WATTS BAR NUCLEAR PLANT (WBN) UNITS 1 AND 2 - RESPONSE TO NRC INFORMATION
REQUEST (TAC R00514, M73097, M73098)

Reference: NRC Audit Summary - Report on the September 1991 Civil
Calculation Audit (TAC R00514, M73097, M73098) Dated
January 31, 1992

WATTS BAR NUCLEAR PLANT
NRC SEPTEMBER 1991 CIVIL CALCULATION AUDIT
RESPONSE TO REQUEST FOR ADDITIONAL INFORMATION

SKETCH 1

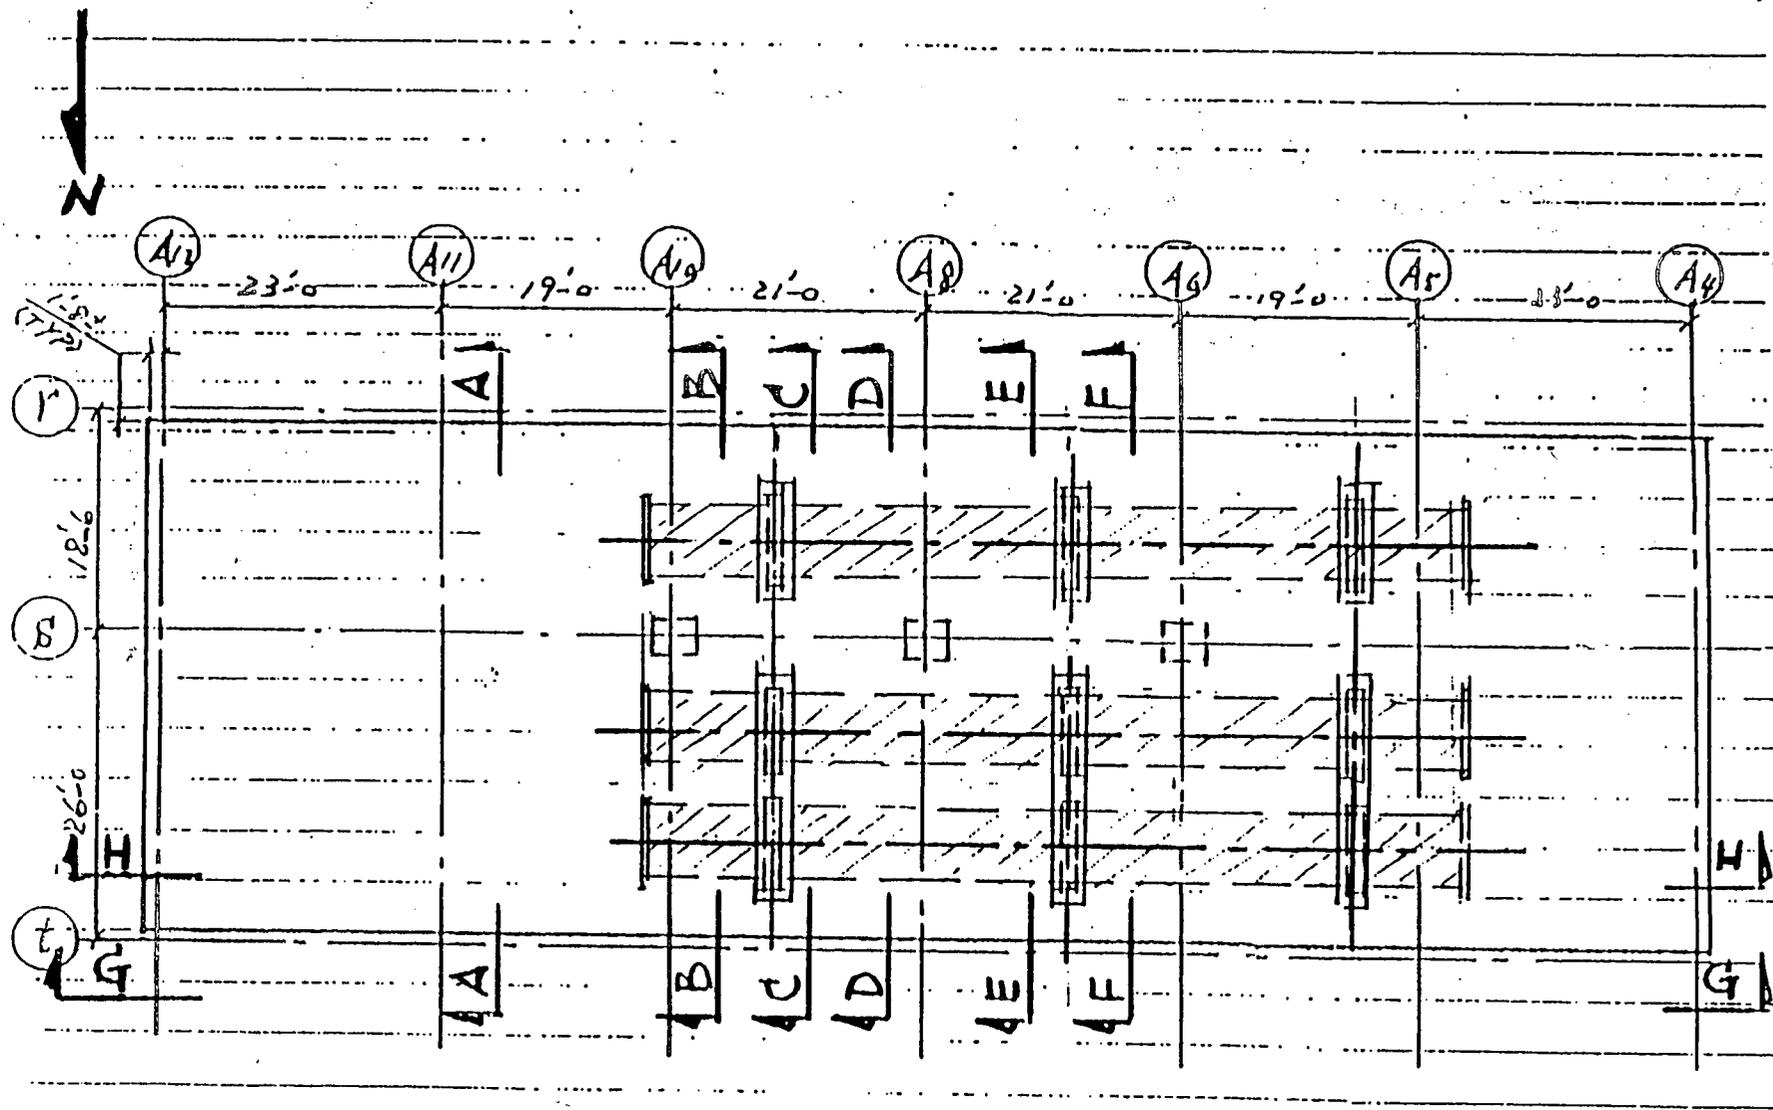
TVA should show the validity of reaction forces and adequacy of the finite element model at the boundary of the slab for calculation WCG-1-923. This evaluation should also be extended to finite element models used for the evaluation of other slab areas.

The arrangement of the equipment and the positioning of the columns supporting the one-foot thick slab at elevation 737 between column lines "r" and "t," as shown on Sketch 1 of Attachment 1, is one of the worst case slab loadings due to the component cooling water heat exchangers. The slab model spans between column lines "r" and "t." The conditions along column line "r" have a continuous beam and were therefore vertically restrained in the model. The conditions along column line "t" have a series of slabs of different thicknesses, intersecting walls and drop panels for columns (see Sketch 2). All slabs thicker than one foot were restrained in the vertical direction while one-foot thick slabs were freed. This model of the boundary conditions resulted in the reaction patterns at column line "t," which include irregular downward and some upward reactions in the vicinities of the freed slab edges. These effects of the idealized model along column line "t" are localized largely in the vicinity of the boundary itself, and rapidly attenuate with distance away from the column line. Sketch 3 provides a deflected shape along the column line "t" at an offset of 4 feet. In contrast the structural behavior of the slab away from column line "t" and in the areas of expected high stress is realistic and accurate. Therefore, the model used in calculation WCG-1-923 is adequate for the evaluation of the slab around column line "s."
